Access Compliance Report

Public Rights-of-Way

(Curb Ramps)

Intersection ID: N/A	Main Street: YORKDALE_DR	Cross Street: MIDLOTHIAN_CT	Location: SE
ADA ID: 3BFDD3128EC4	Ramp Type: Perp	Initial Pass/Fail: Fail	Overall Compliance: No
		Severity Score: 12.5

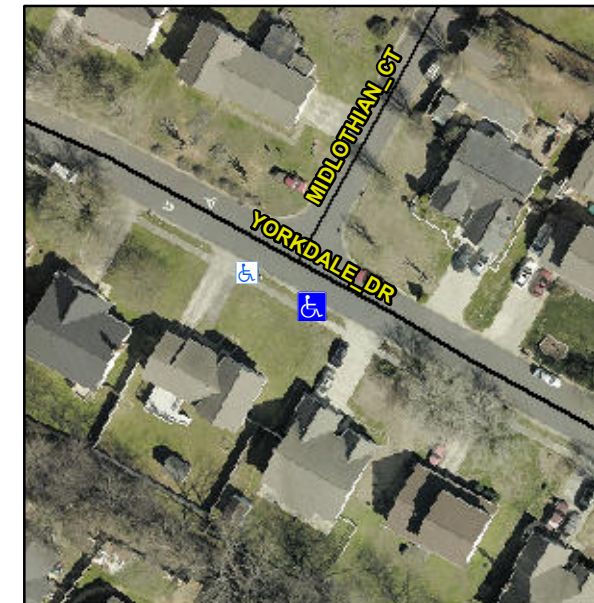
R304.2.2

Compliance	Description	Data	Compliance	Description	Data
N/A	Ramp Length (in)	46.0	No	Ramp Slope (%)	11.1
Yes	Ramp Width (in)	97.0	Yes	Ramp XSlope (%)	1.4
N/A	Flare Type LT	N/A	N/A	Flare Type RT	N/A
N/A	Flare Slope LT (%)	N/A	N/A	Flare Slope RT (%)	N/A
N/A	Flare Traversable LT?	N/A	N/A	Flare Traversable RT?	N/A
N/A	Landing Length (in)	N/A	N/A	DWS Provided?	N/A
N/A	Landing Width (in)	N/A	N/A	DWS Contrast?	N/A
N/A	Landing Slope (%)	N/A	N/A	DWS Length (in)	N/A
N/A	Landing X Slope (%)	N/A	N/A	DWS Full Width?	N/A
N/A	Landing Curb? (Y/N)	N/A	N/A	DWS Offset (in)	N/A
N/A	Shared Landing?	N/A			
N/A	Gutter Ponding?	N/A	N/A	Gutter Slope (%)	N/A
N/A	Gutter Lip Ht (in)	N/A	N/A	Gutter X Slope (%)	N/A
N/A	Painted X Walk1?	No	N/A	Painted X Walk2?	N/A
	X Walk 1 Direction	To NE		X Walk 2 Direction	N/A
N/A	X Walk 1 Width (in)	N/A	N/A	X Walk 2 Width (in)	N/A
	X Walk 1 Slope (%)	5.5		X Walk 2 Slope (%)	N/A
	X Walk 1 X Slope (%)	3.2		X Walk 2 X Slope (%)	N/A

Remove & Replace Entire Ramp.
